**RESPONSE TO TECHNICAL
COMMENTS**

Fidelity Roof Company
1075 40th Street
Oakland, California

Project No. 4436

**Re: Fidelity Roof Company - 1075 40th Street, Oakland, CA; Fuel Leak Case RO0000186;
Underground Storage Tank Cleanup Fund Claim #13833**

AEI CONSULTANTS	
2500 CAMINO DIABLO, SUITE 200, WALNUT CREEK, CA	
PROPOSED WELL LOCATION MAP	
1075 40TH STREET OAKLAND, CALIFORNIA	FIGURE A-1 PROJECT NO. 4436

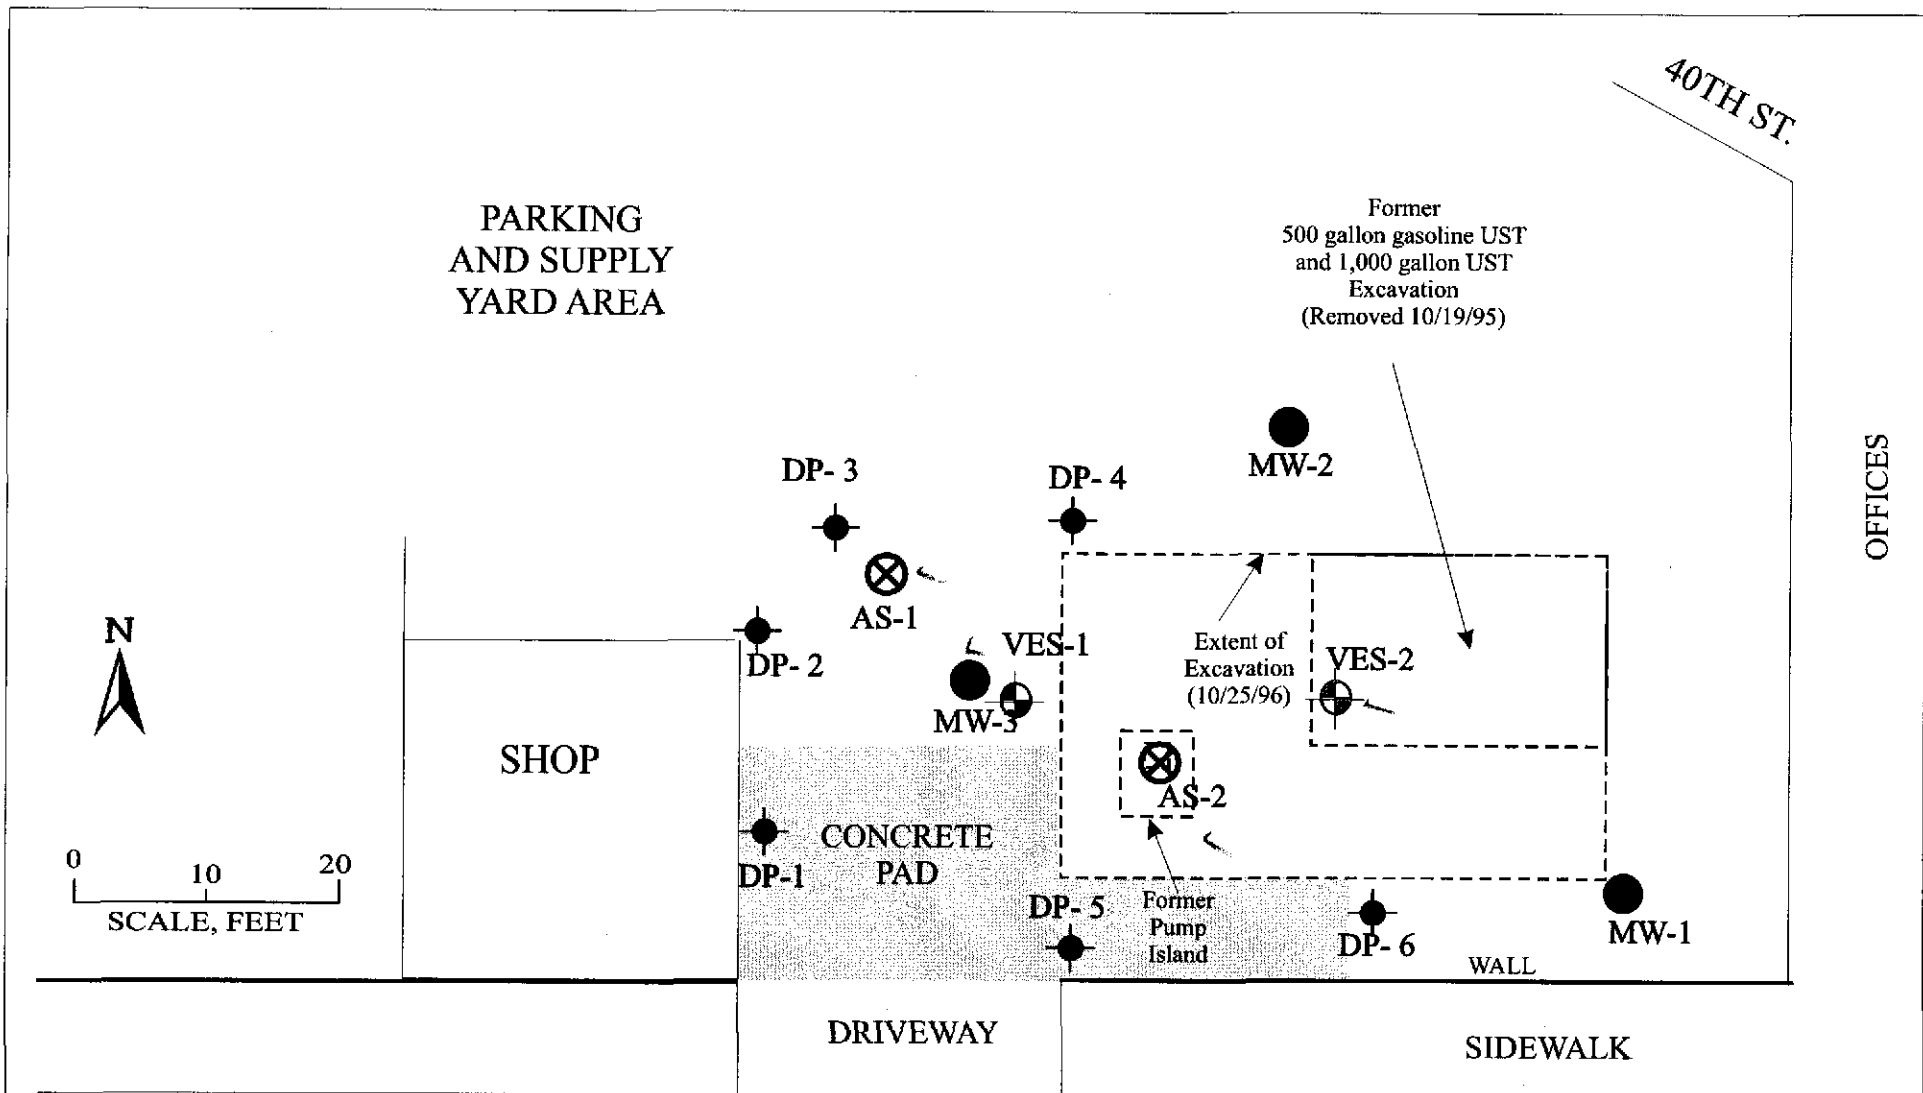
The ACHCSA also indicated that the vapor extraction would be enhanced in the excavated and backfilled areas, however that no AS wells are proposed within this area.

The ACHCSA also indicated that the pilot test should show the viability and effectiveness of this type of remediation. The ACHCSA also indicates that beyond the former excavation, the effectiveness of vapor extraction is expected to be less and that the pilot test should extend to outside the excavation to confirm the radius of influence (ROI) in this area.

Proposed AS-2 will be placed in the excavated area as shown on Figure A-1 in Appendix A.

The pilot testing will address the most contaminated area around MW-3. Figure A-1 in Appendix A shows the proposed VES and AS wells as well as drive points that will be used for monitoring during the pilot test.

Drive points are placed at varying distances from VES-1, which is located outside the excavated area. VES-1 will be used for the first (if any others tests are required) based on the expected lower permeability of the undisturbed area. If well response is not observed in a sufficient number of wells or within the excavation, a second VES test using VES-2 will be conducted. The AS test will be conducted at AS-1 or AS-2 depending on which VES well was used successfully (or most successfully).
